Serial: NPD-NRC-2009-101
June 10, 2009

**LEVY NUCLEAR POWER PLANT, UNITS 1 AND 2
DOCKET NOS. 52-029 AND 52-030
RESPONSE TO REQUEST FOR ADDITIONAL INFORMATION LETTER NO. 028 RELATED TO
EMERGENCY PLANNING – EVACUATION TIME ESTIMATE**

**Levy Nuclear Power Plant Units 1 and 2
Response to NRC Request for Additional Information Letter No. 028 Related to
SRP Section 13.3 for the Combined License Application, dated May 8, 2009**

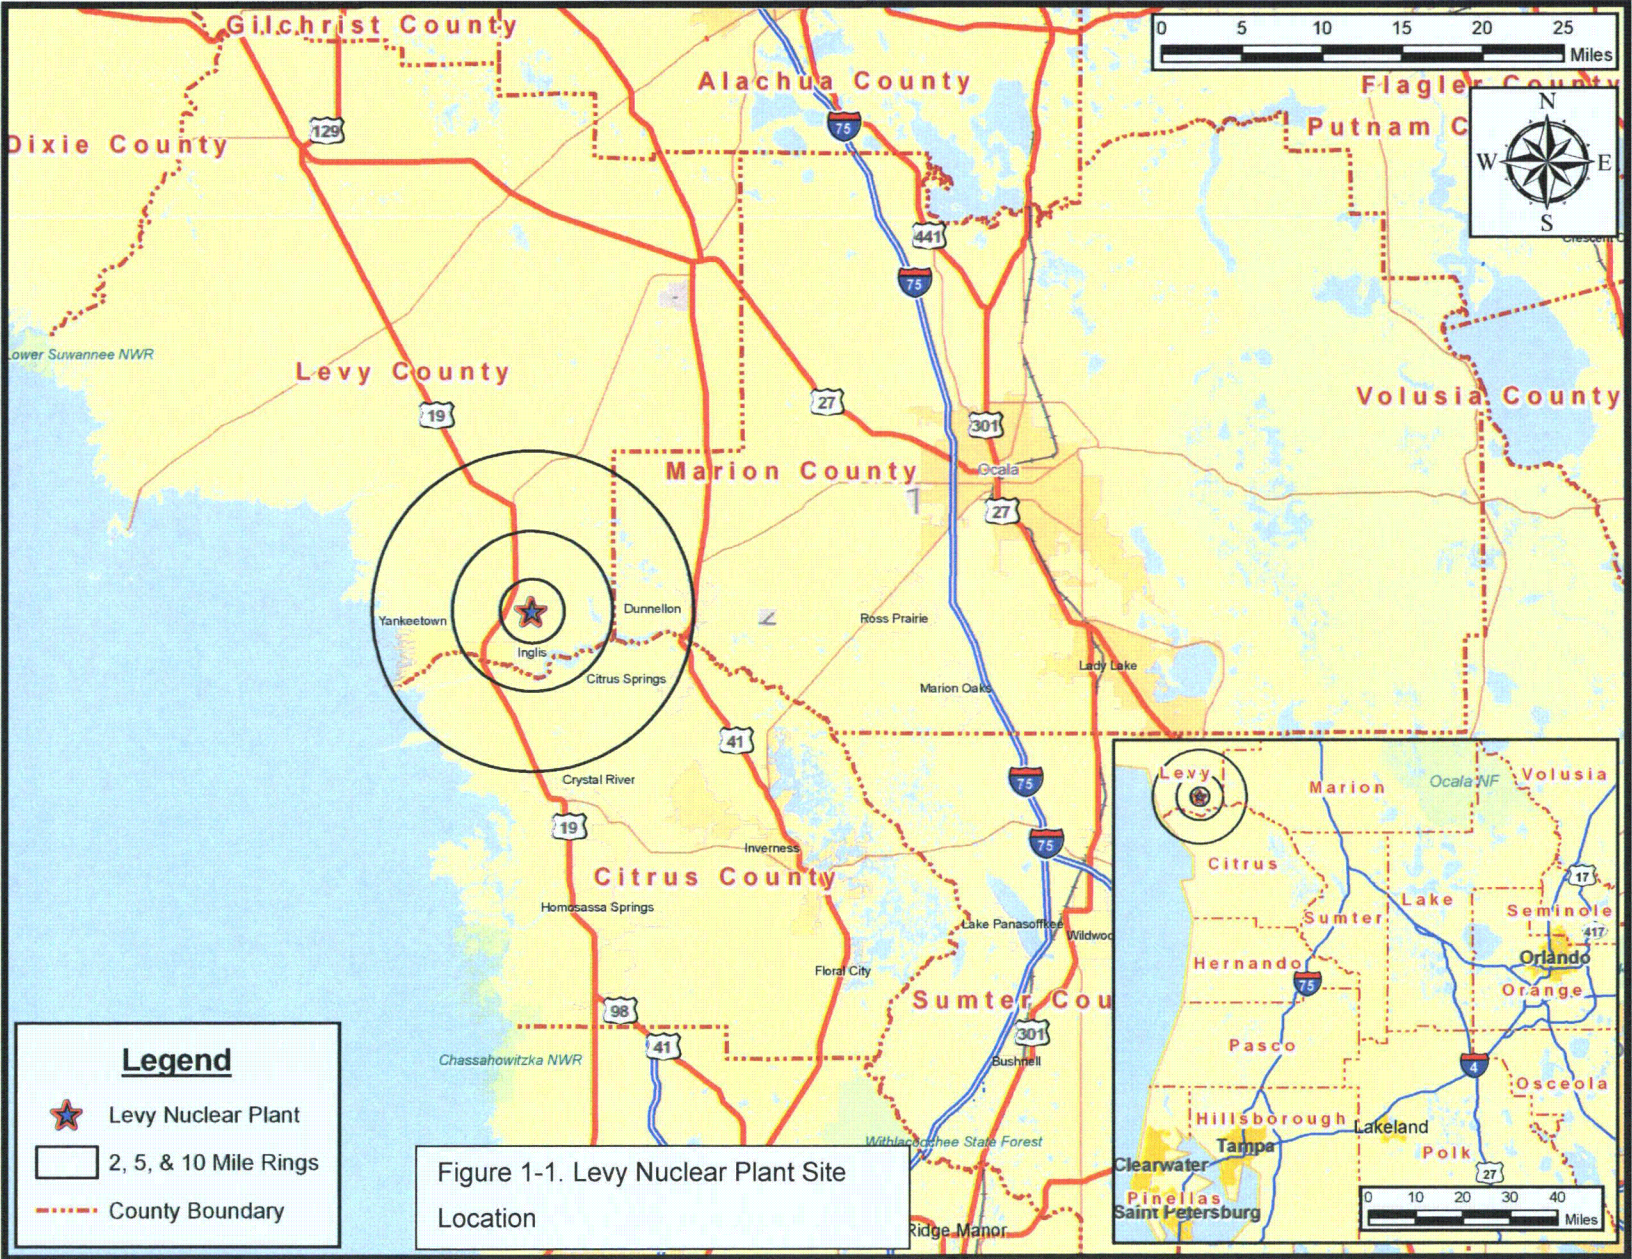
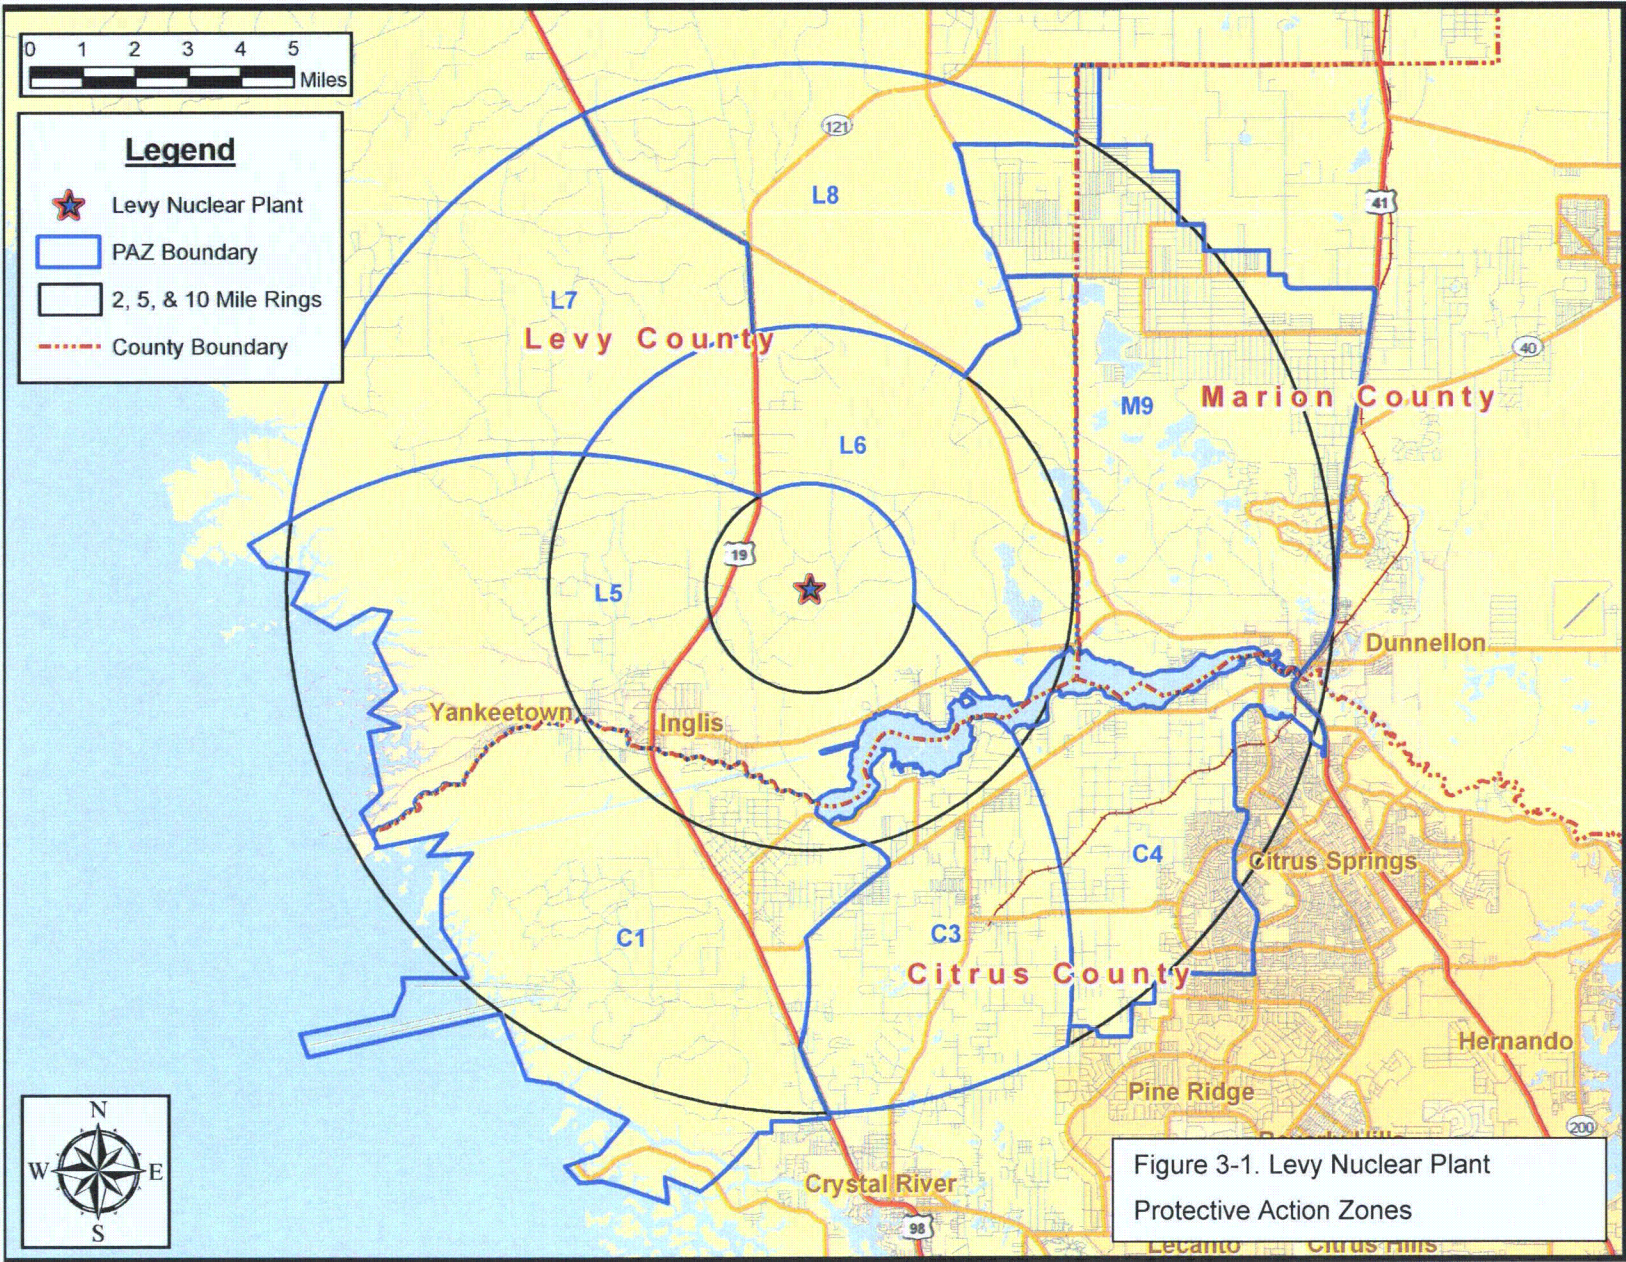
- A. Figure 1-1, "Levy Nuclear Plant Site Location," (Page 1-4) shows the LNP with the 2-, 5-, and 10-mile rings within the plume exposure pathway EPZ. Communities and county boundaries within the 2-, 5-, and 10-mile rings are not clearly labeled. Provide maps that include surrounding communities, county boundaries, and political boundaries.

There are four communities within 10 miles of the proposed Levy Nuclear Plant (LNP) site – Yankeetown, Inglis, Dunnellon and Citrus Springs. Figure 1-1 has been revised (see attached) to include these communities. The LNP EPZ includes three counties – Levy, Citrus and Marion. The revised version of Figure 1-1 clearly identifies the EPZ county boundaries and labels these counties. The revised map focuses on the Levy EPZ and the three counties comprising the EPZ, while the newly added inset to the map shows the location of the Levy EPZ relative to the major population centers in the area – Tampa and Orlando. In addition, communities and counties in the surrounding area have been identified on the revised figure.

Figure 3-1 has also been revised to include the aforementioned communities and counties, appropriately labeled.

1. Replace Figure 1-1 with the revised figure shown on page 4.
2. Replace Figure 3-1 with the revised figure shown on page 5.
3. Section 1.2 of the ETE report will be revised as follows:

Figure 1. Comparison of ETE and Trip Generation Time
Levy Nuclear Plant
Evacuation of Region R03, Scenario 1

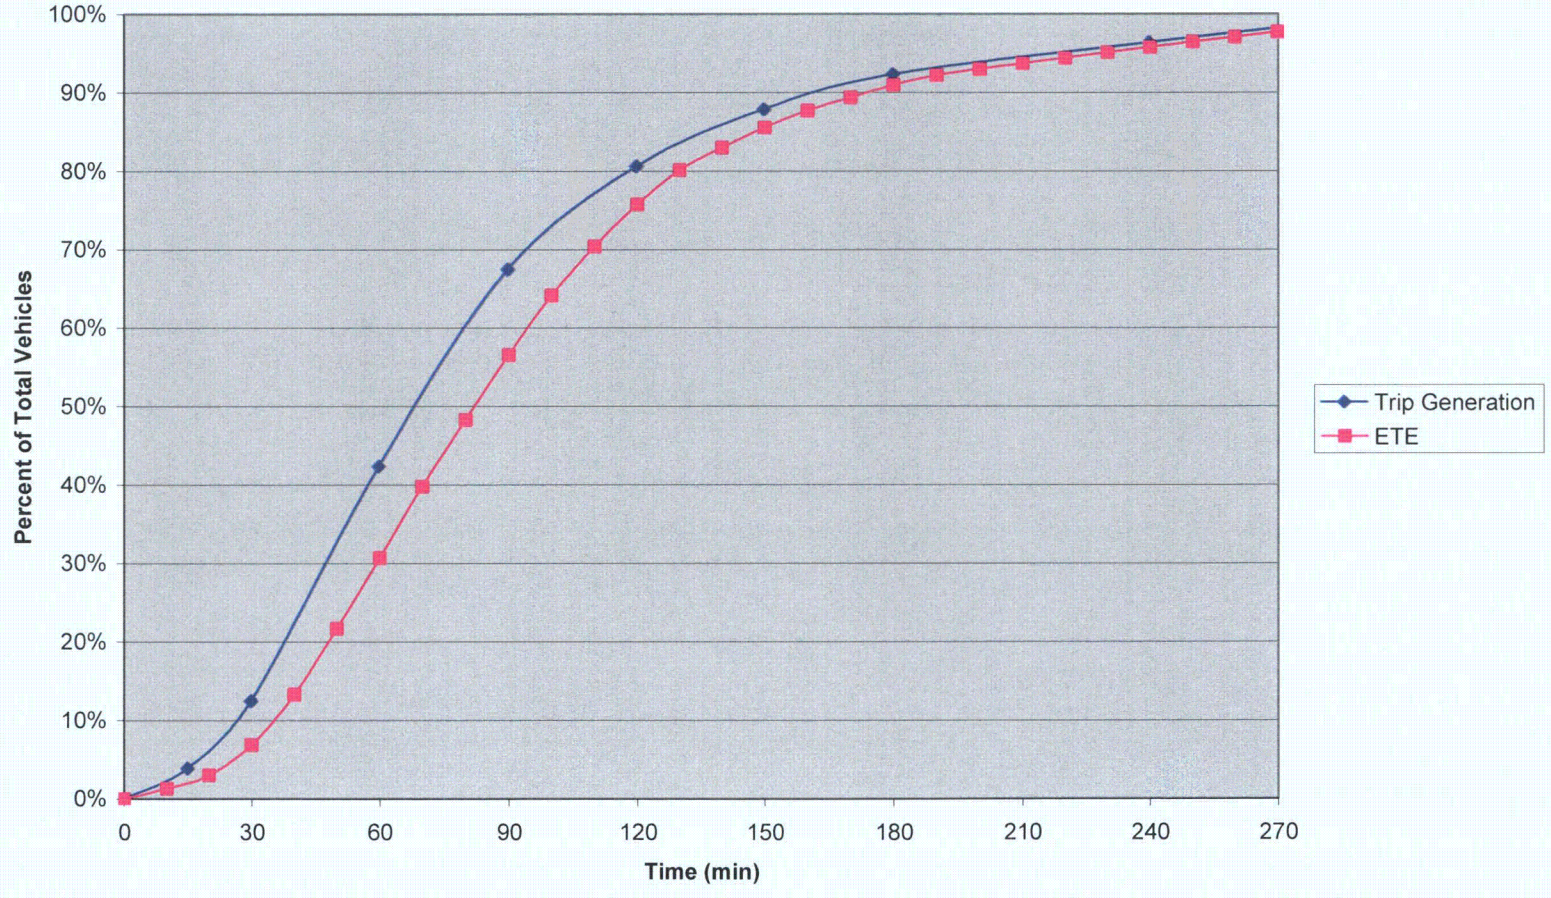
- B.** Section 2.1, "Data Estimates", (Page 2-1) assumption #7 states that the ETEs are presented for the evacuation of the 100th percentile. The evacuation times provided in Section 7, "General Population Evacuation Time Estimates (ETE)," indicate ETEs of about 5 hours for the general population, whereas the telephone survey results in Figure F-11, "Time to Prepare Home for Evacuation," (page F-10) indicate that it may take as long as 6 hours for the general public to prepare to evacuate. Clarify the inconsistency in the time it takes to evacuate 100 percent of the general population.

The attached Figure 1 (see page 14) illustrates that the ETE for the LNP EPZ is dictated by the mobilization time. The horizontal distance between the trip generation curve and the ETE curve represents the travel time to the EPZ boundary. The short travel times (closeness of the two curves) indicate there is not pronounced traffic congestion within the EPZ delaying the departure of evacuees from the EPZ. Therefore, the establishment of TCPs strictly to manage traffic congestion is not necessary; however, the establishment of TCPs is recommended to provide guidance and reassurance to evacuees, and fixed point surveillance as noted above.

Figure F-8. Number of Vehicles Used for Evacuation

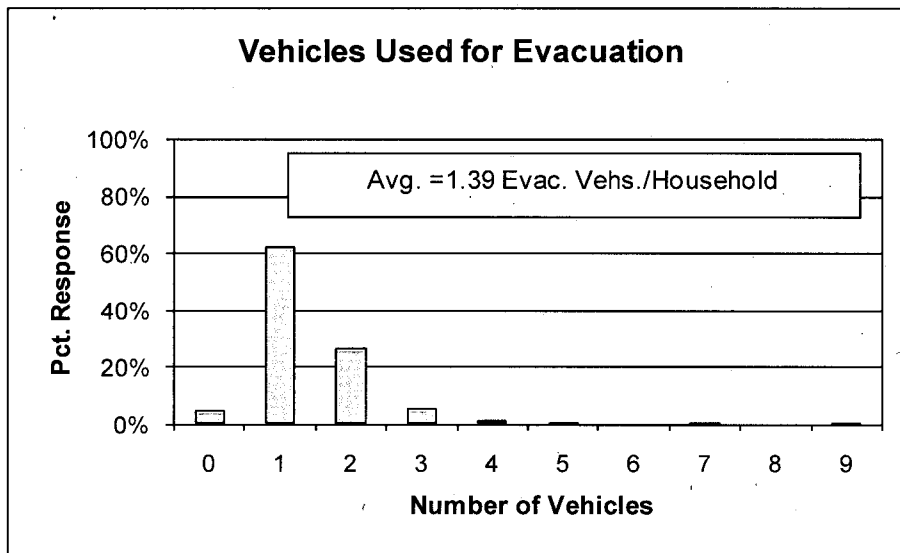
- A.** Section 3, "Demand Estimation," (Page 3-2) provides a description of estimations used for the permanent resident population, household, and vehicles. The average number of evacuating vehicles per household adapted from the telephone survey is assumed to be 1.32 vehicles per household (Table 1-1, Page 1-9). However, Figure F-2, "Household Vehicle Availability," (Page F-4) indicates that there are 1.82 vehicles per household, and subsection "Evacuation Response," (Page F-7) indicates an average of 1.37 vehicles per household.

1. Clarify which value for the number of vehicles per household is correct and used in the calculation.
 2. Clarify whether the data presented in Table 3-2, "Permanent Resident Population and Vehicles by Protective Action Zone (PAZ)," (Page 3-4) and in Figure 3-3, "Permanent Resident Vehicles by Sector," (Page 3-6) will need to be updated if the number of vehicles per household value is changed.

As stated in Table 1-1 of the ETE report, a value of 1.32 vehicles per household was used to estimate the number of vehicles evacuating. Figure F-8 indicates an average of 1.37 vehicles per household. Both of these values are incorrect. The correct value is 1.39 evacuating vehicles per household, as shown in Table 1. Figure F-8 omitted the single house which indicated 9 vehicles would be used for evacuation, which resulted in the lower weighted average of 1.37 vehicles.

- Replace Figure F-8 with the attached revised figure (see page 33).
- Re-compute the number of evacuating vehicles for permanent residents in the EPZ and in the Shadow Region using the correct value of 1.39 evacuating vehicles per household and update the vehicle loading onto the analysis network accordingly. Re-run all the ETE cases using the updated vehicle loading. Update Tables 7-1A through D (7-1C and 7-1D also appear in the Executive Summary), Tables J-1A through D, Figures 7-3 through 7-7 and Figures J-1 through J-11.

Figure 5-1. Events and Activities Preceding the Evacuation Trip

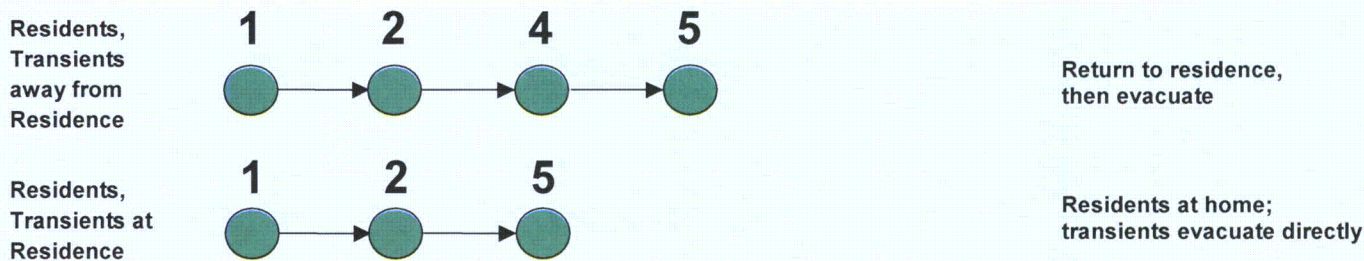
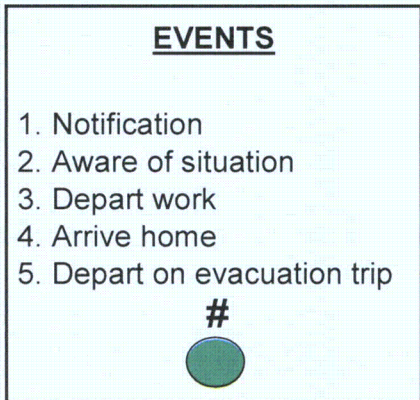
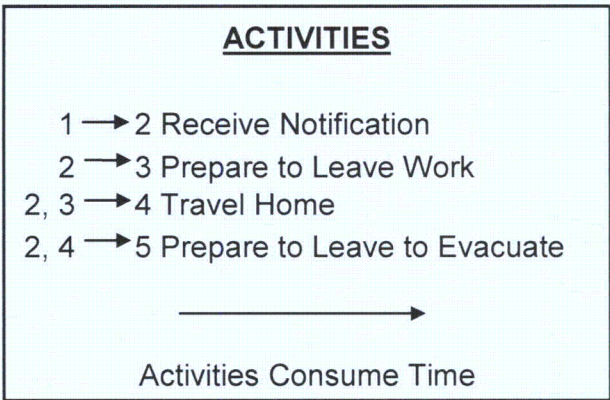
- C. Mobilization of the permanent resident, transient, and employee population is discussed in Section 5, "Estimation of Trip Generation Time." Figure 5-1(b), (Page 5-3) shows that transients will be: 1. Notified, 2. Become aware of the incident, and then 3. Begin evacuation trip. The figure suggests that transients would not be returning to their "residence" prior to an evacuation. Explain why the possibility for transients to return to a location to gather belongings was not considered in the evacuation time estimate.

Figure 5-1 is revised as attached (see page 41) to include the possibility that transients may return to lodging facilities or campsites prior to beginning their evacuation trip. The text of Section 5 will be revised to agree with the changes to Figure 5-1.

An employee who lives outside the EPZ will follow sequence (c) of Figure 5-1. A household within the EPZ that has one or more commuters at work, and will await their return before beginning the evacuation trip will follow the first sequence of Figure 5-1(a). A household within the EPZ that has no commuters at work, or that will not await the return of any commuters, will follow the second sequence of Figure 5-1(a), regardless of day of week or time of day. Note that event 5, "Leave to evacuate the area," is conditional either on event 2 or on event 4. For this study, we adopt the conservative posture that all activities will occur in sequence.

Households with no commuters on weekends or in the evening/night-time, will follow the applicable sequence in Figure 5-1(b). Transients will always follow one of the sequences of Figure 5-1(b). Some transients away from their residence could elect to evacuate immediately without returning to the residence, as indicated in the second sequence.

**Figure 1. Levy/Crystal River
Overlap**

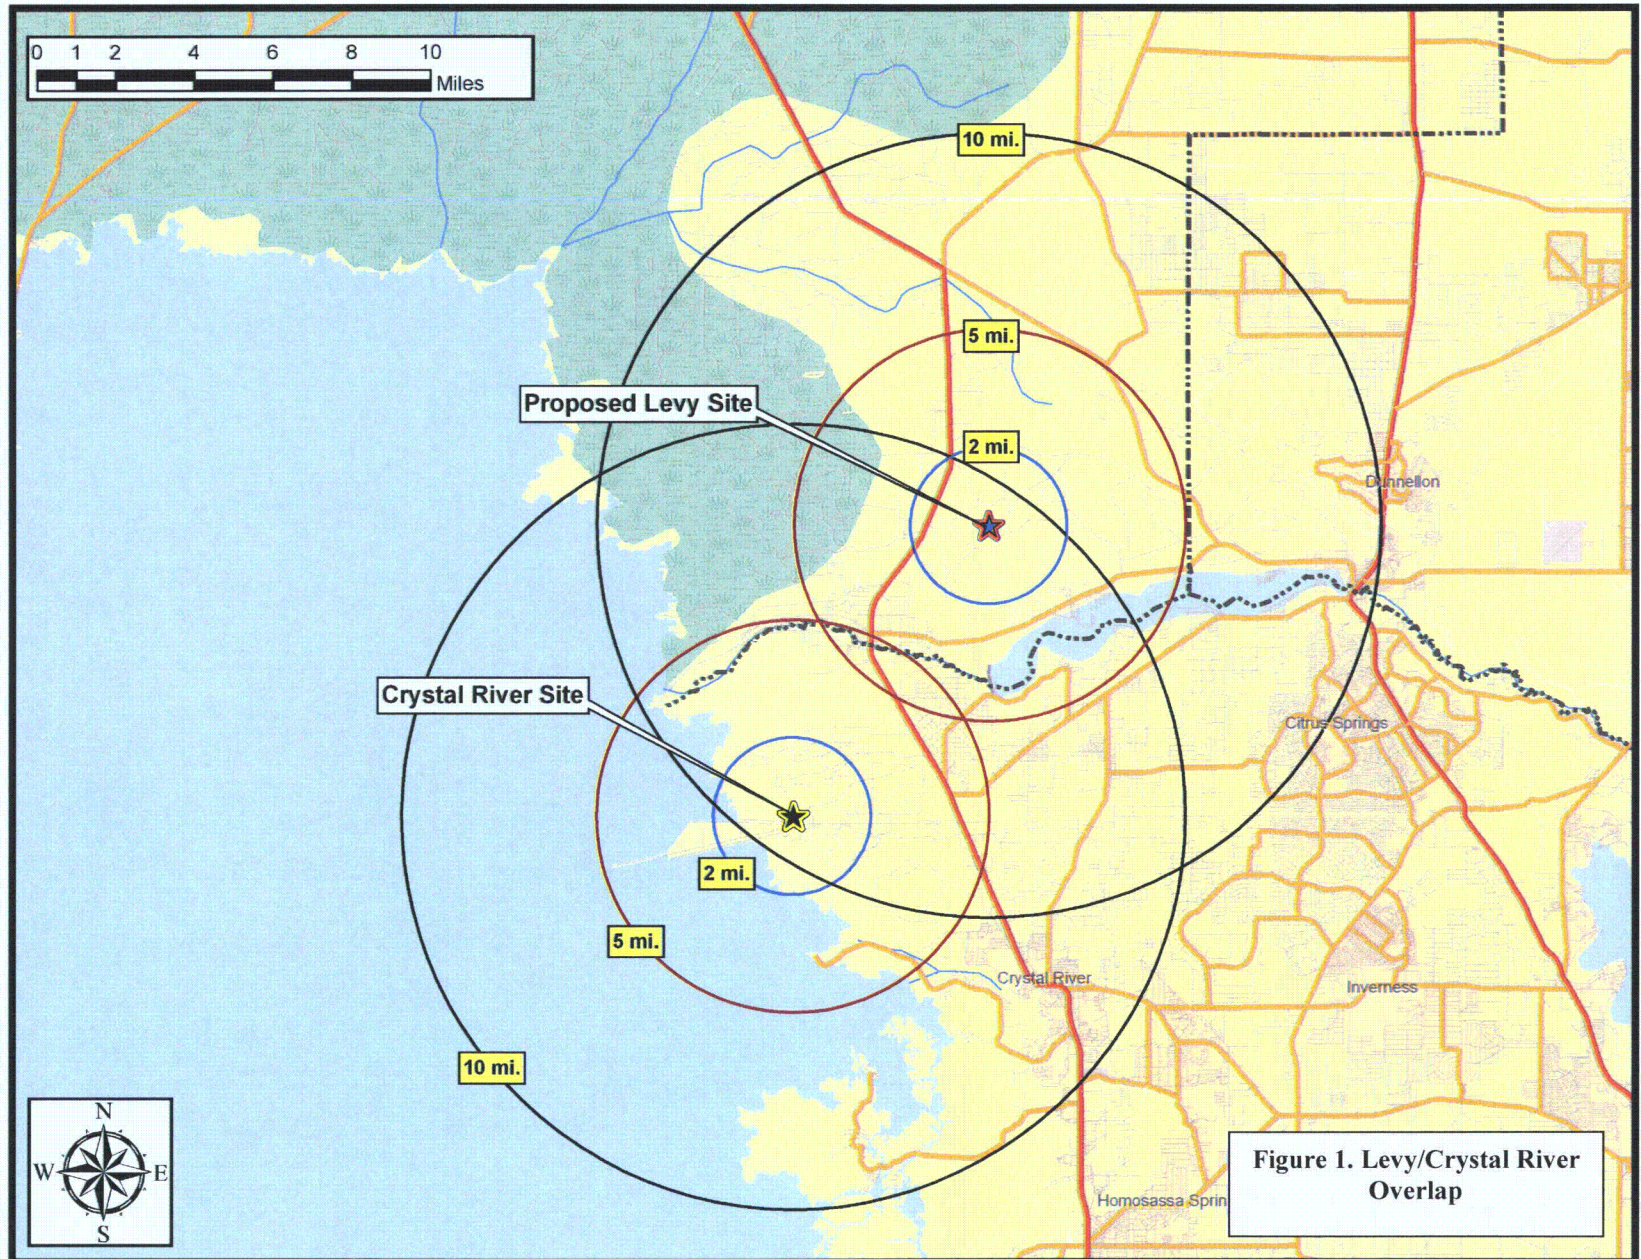
- A. The physical boundaries of the PAZs are described in Appendix L, "Protective Action Zone Boundaries." All zones are bound by major roads, county lines, city/town boundaries, lakes, rivers, or Crystal River Nuclear Plant PAZ boundaries. The Dunnellon and Citrus Springs communities appear to be bisected by PAZs C4 and M9 according to Figure 3-1, "Levy Nuclear Plant Protective Action Zones," (Page 3-3). Clarify whether a densely populated area has been bisected by this boundary. If so, provide a resolution for the boundary for these zones.

A. The proposed Levy Nuclear Plant site is approximately 9.8 miles northeast of the existing Crystal River Nuclear Plant. There is considerable overlap (see attached Figure 1 on page 71) of the 10-Mile radii surrounding each plant, due to the close proximity of the two plants. Progress Energy contracted KLD Associates, Inc. to develop ETE for the proposed Levy site as well as update the ETE studies for the existing Crystal River plant. Part of this work effort was to identify a set of Protective Action Zones (PAZ) that was suitable for both sites. The design of these combined PAZ was first discussed at a project kickoff meeting on February 14, 2007 with representatives from Progress Energy, KLD Associates, the State of Florida and the EPZ counties. A large scale paper map was marked up with draft PAZ boundaries. Another meeting was held on June 19, 2007 at which the EPZ/PAZ boundaries were finalized.
